Southern Nuclear Operating Company
Vogtle Electric Generating Plant Units 3 and 4
Supplement to Revised Request for License Amendment:
Containment Internal Floor Module Connections (LAR-15-012 R1S)

Enclosure 3

Responses to NRC Staff Comments

(LAR-15-012 R1S)

Figure 2: Elevation View of CA37 Floor to CA01 Wall Connection

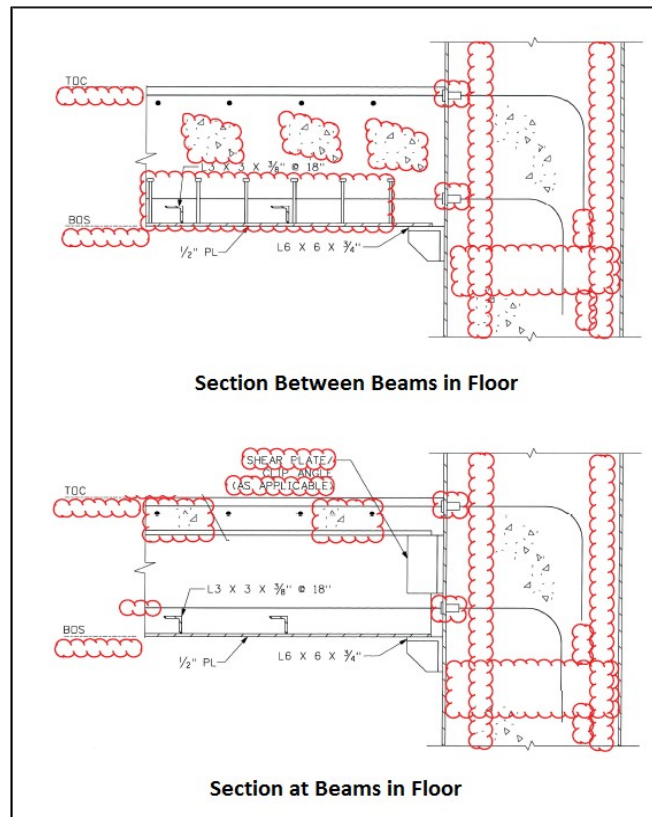
Provide a table to demonstrate the demand to capacity ratio of the connection at various sample locations, including locations where the top of the wall is at the same elevation as the top of the floor.

Figure 2 (revised UFSAR Figure 3.8.3-17 (Sheet 1 of 2) as proposed in SNC LAR-15-012R1 and shown below) shows the configuration of the CA37 module floor-to-CA01 wall connection (Area 4 in Containment, top of floor elevation 107'-2"). This connection is composed primarily of encased steel beams that are welded to continuous stiffened angle beam seats. The seats are continuously welded to the CA01 module wall faceplate. Additionally, there are top and bottom dowels that connect the CA37 floor to the CA01 wall. At some locations where the encased beams are heavier to carry heavier loads, such as the Core Makeup Tank, there are heavy beam seats instead of the continuous stiffened angle. These heavy beam seats are referred to as beam pedestals.

Table 1 describes the interaction ratios for the CA37 module floor to CA01 module wall connection (Area 4 in Containment, top of floor elevation 107'-2").

Item	Structural Item	Demand	Capacity	IR	Governing failure mode
1	Top dowel	1.32 in ² /ft	2.00 in ² /ft	0.66	Maximum 0.3% concrete compressive strain in bending per ACI 349 requirements.
2	Bottom dowel	1.96 in ² /ft	2.00 in ² /ft	0.98	Maximum 0.3% concrete compressive strain in bending per ACI 349 requirements, determined conservatively neglecting the contribution of the encased beams, the floor bottom plate and the weld to the floor seat.
3	Continuous Stiffened Beam Seat	4.94 kip/in	5.57 kip/in	0.89	Weld connecting floor bottom plate to continuous angle seat, determined conservatively neglecting the contribution of the bottom dowels.
4	Beam Pedestals	12.6 kip/in	50.4 kip/in	0.25	Weld connecting beam to beam pedestal.

Table 1 displays the reinforcement required (see items 1 & 2 in the table) in square inches per linear foot to withstand the demand forces due to axial, bending, & twisting loads from the ANSYS finite element analysis model while neglecting the contribution of the beam seats. The capacity is presented as the available square inches of steel per linear foot.

Table 1 also displays the continuous stiffened angle floor seat (see item 3 in the table) "demand" due to tension (axial, bending, & twisting moment), in-plane shear, and out-of-plane shear loads from the ANSYS finite element analysis model, along with locked-in stress imparted to the seats during concrete placement. The forces applied at the stiffened seat for the evaluation are conservatively based on the largest demand obtained from the analysis model at the CA37 floor to wall connection, while neglecting the contribution of the bottom dowels. The continuous stiffened beam seats are demonstrated to meet the design requirements.

Finally, Table 1 also displays the beam pedestal (see item 4 in the table) "demand" due to in-plane shear and out-of-plane shear loads from the ANSYS finite element analysis model. The beam pedestals are analyzed in a similar fashion as the continuous stiffened angle beam seats with the exception that they see larger loads due to the Core Makeup Tank being supported on this area of the floor.
